**CITY OF RIPLEY
JACKSON COUNTY, WEST VIRGINIA**

**PHASE II – PROPOSED SANITARY SEWER SYSTEM IMPROVEMENTS PROJECT
CONTRACT #3 – PROPOSED 1.2 MGD WASTEWATER TREATMENT PLANT**

ADDENDUM #2

MARCH 23, 2022

SHEET No.
74

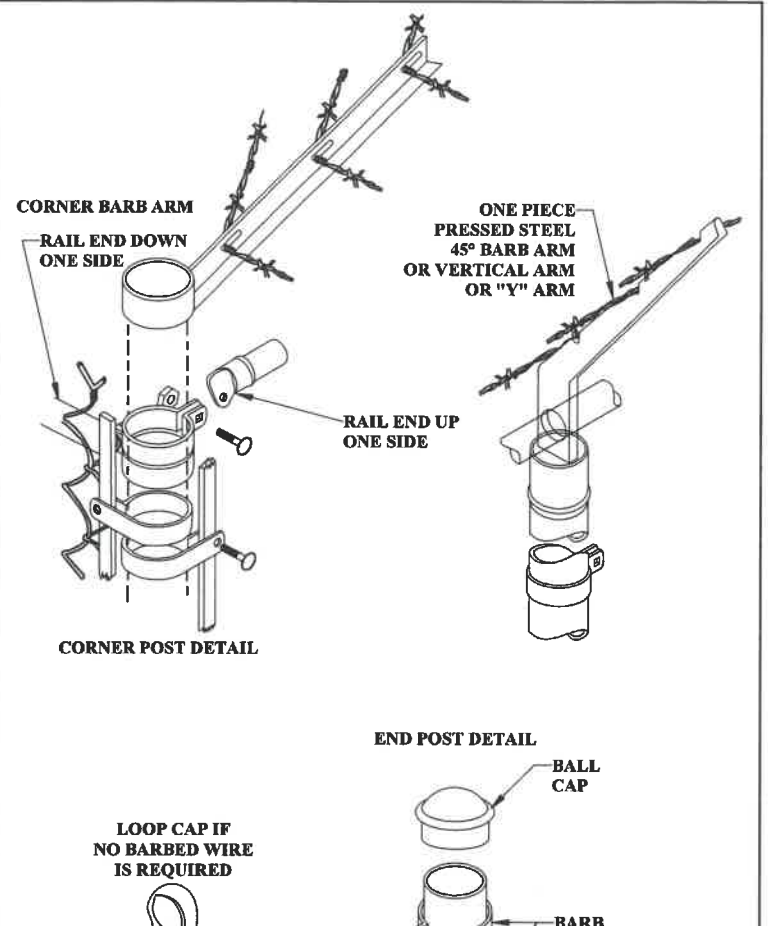
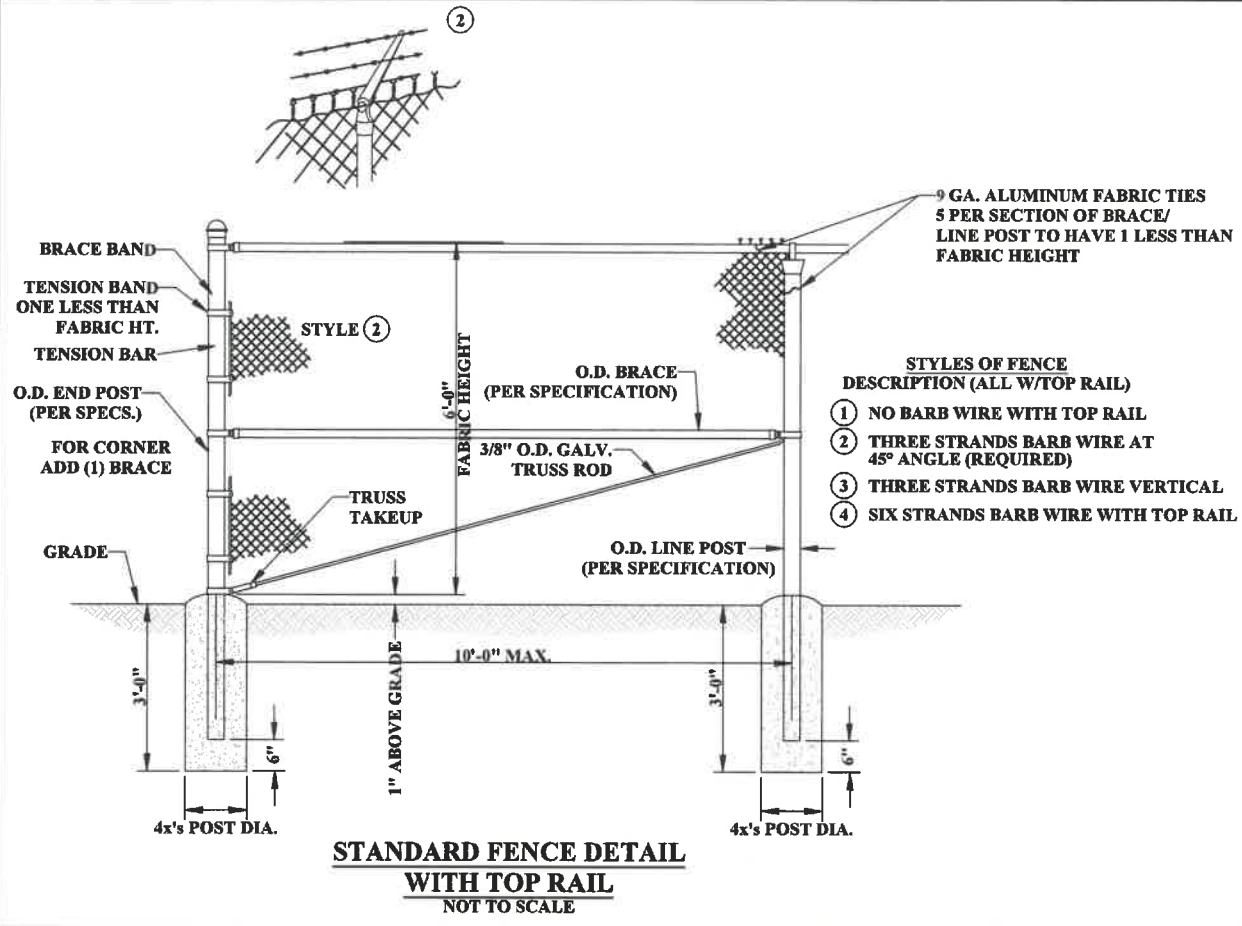
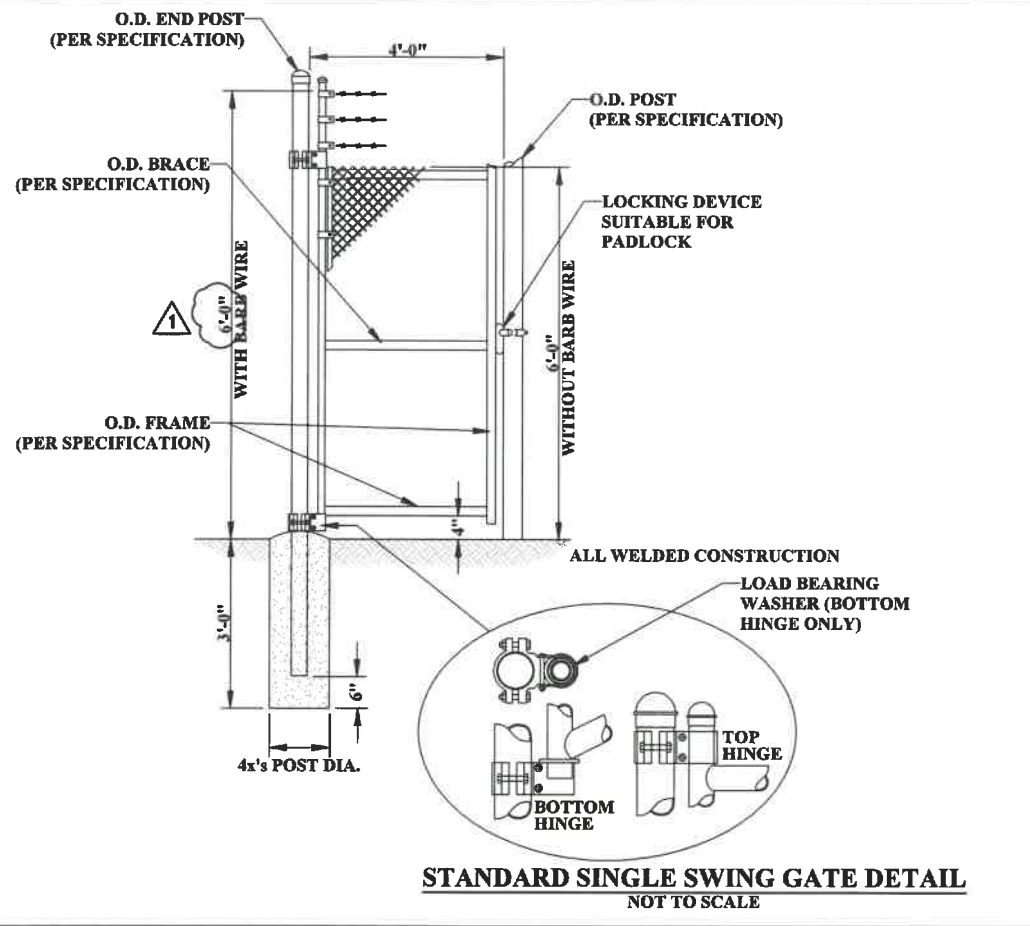
9. Sheet 74
 - a. Blower discharge has been revised to 2”, as described in Specification 461405.
10. Sheet 153
 - a. Revised to show thermostats in place of space heaters for motors.

SHEET No.
104

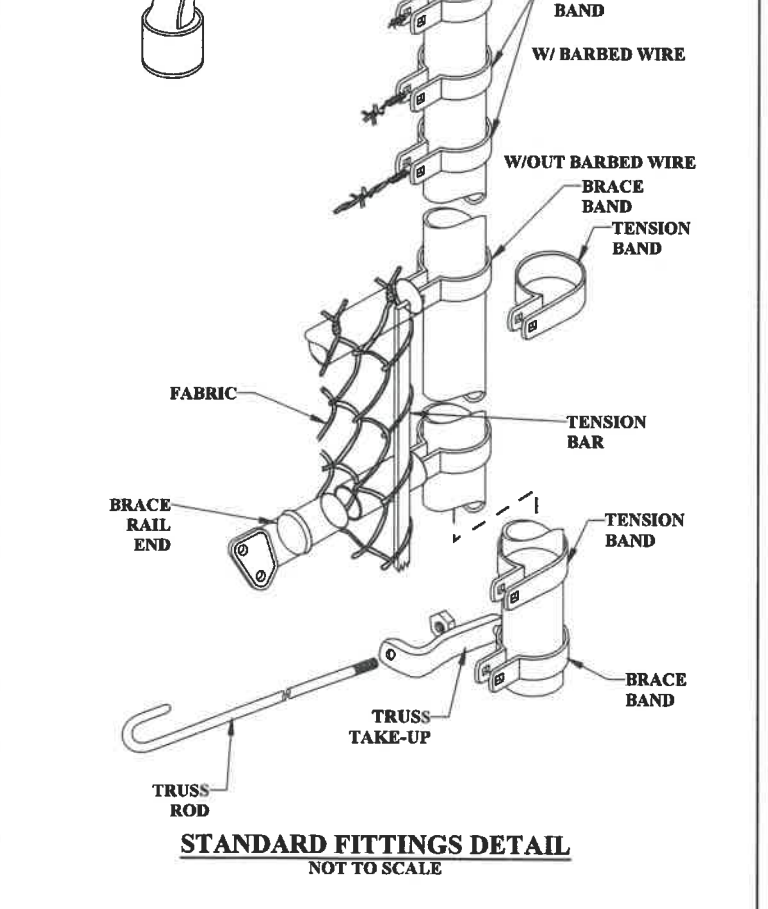
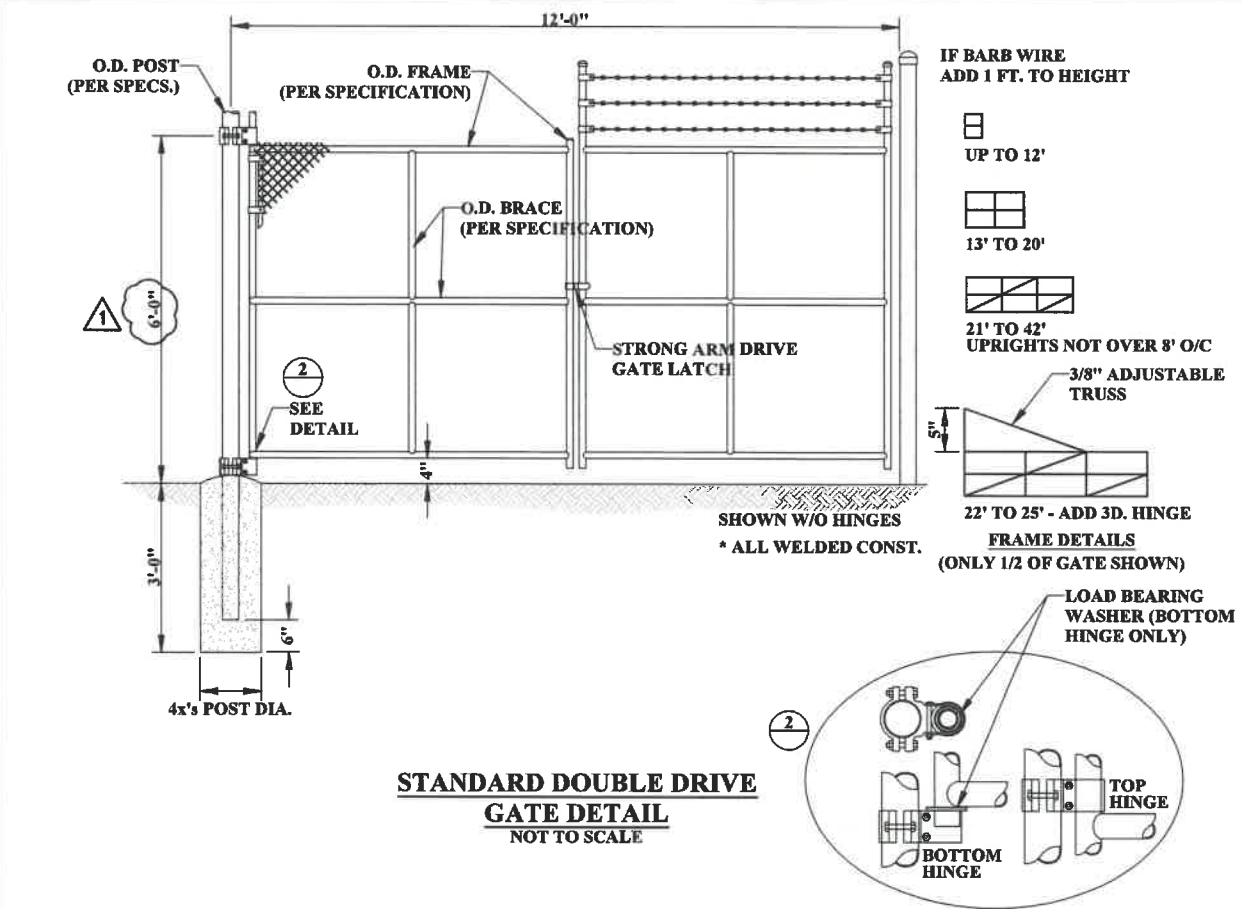
3. There is not a specification for the perimeter fence. Is the fence 6'-tall with 3-strands of barbed wire in all locations? Please provide pipe sizing, pipe specifications, and fabric specifications.

The fence is 6'-tall with 3-strands of barbed wire in all locations. Specification 323113 – Chain Link Fence and Gate has been added to the contract as part of this addendum to clarify fencing requirements. The fence details on Plan Sheet 104 have been updated to reflect the fence specified.

SHEET No.
171

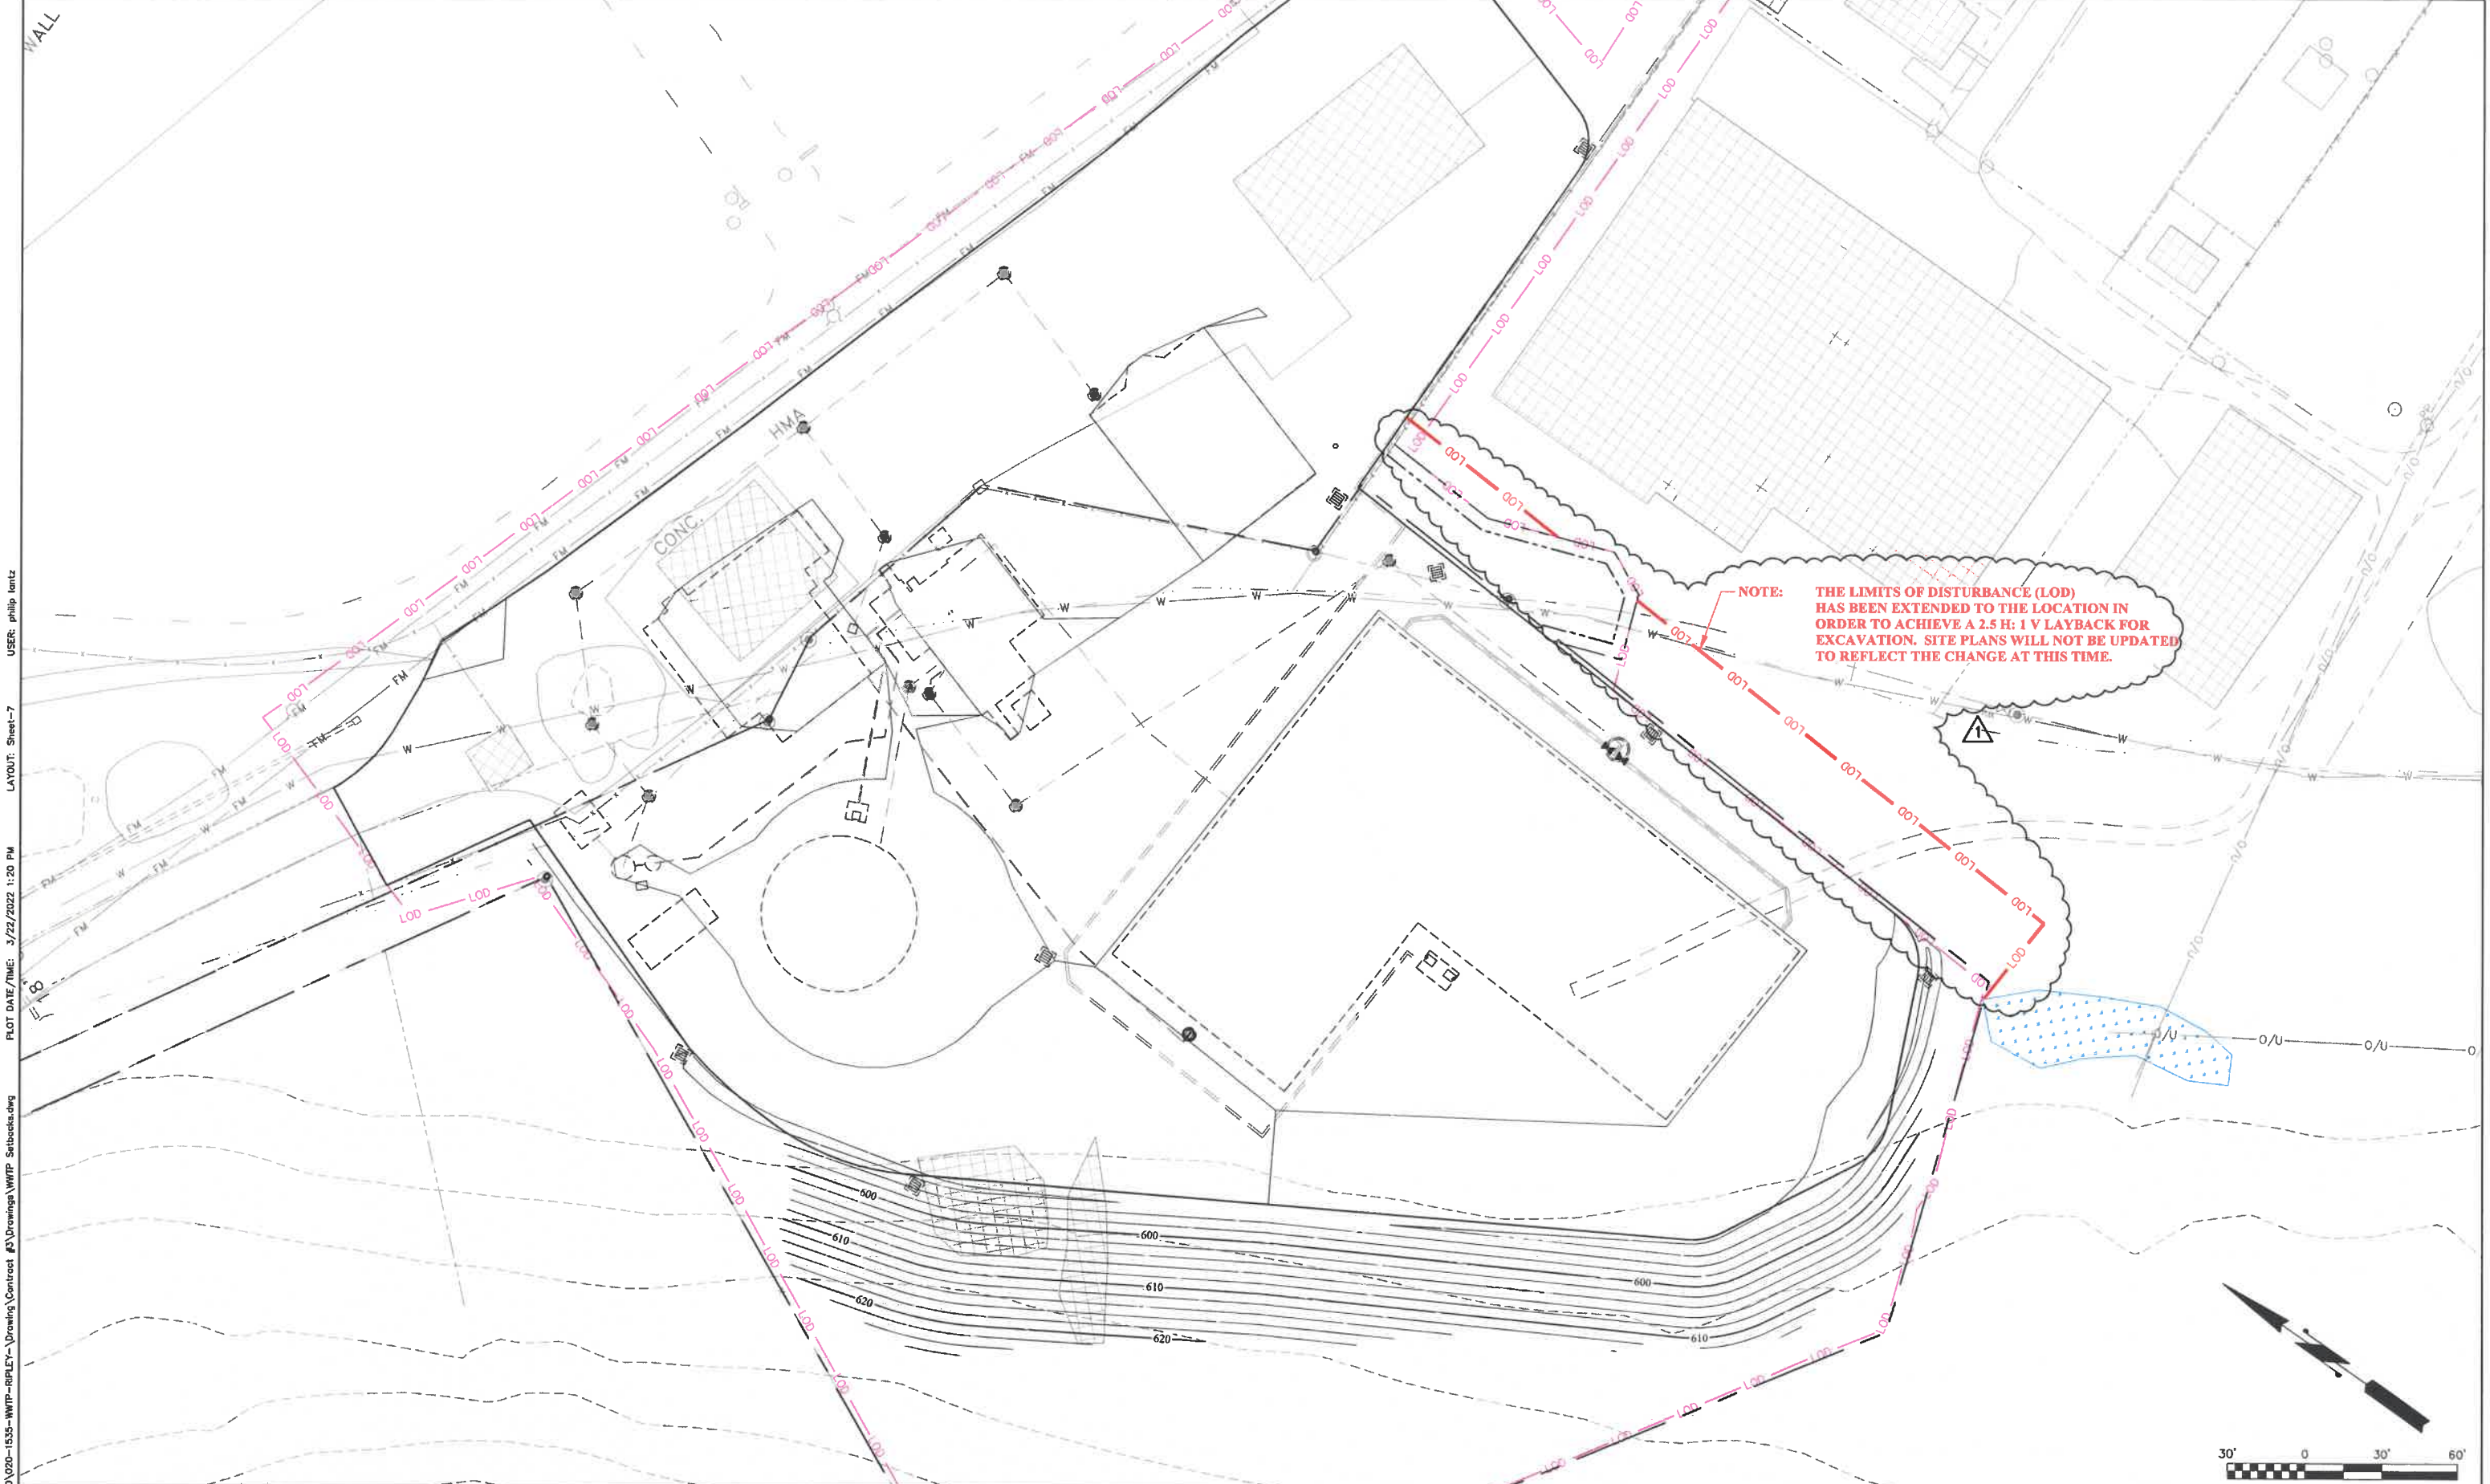
11. Sheet 171
 - a. Revised to include Pre-EQ float switch.
 - b. Sludge pumps have been changed to 5 HP.
 - c. Based on the required flow rate and TDH, the Post-EQ pumps have been changed to 12 HP.
